Product Change Notice

HOLLAND ILS No-Tilt Sliding Fifth Wheel Assembly

This product change notice applies to all HOLLAND ILS No-Tilt sliding fifth wheel assemblies.

New Tie Bar

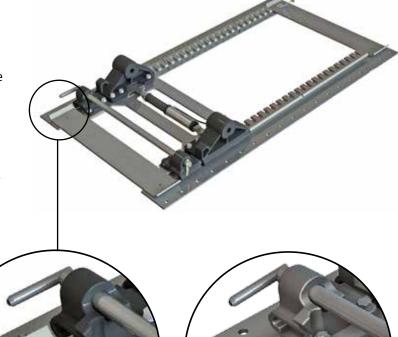
As of June 4, 2014, SAF-HOLLAND has implemented a tie bar design change for all ILS No-Tilt sliders. Please refer to the images for the new tie bar. While parts numbers have not changed, fifth wheel assembly weights have increased by 4 lbs. New weights are listed below.
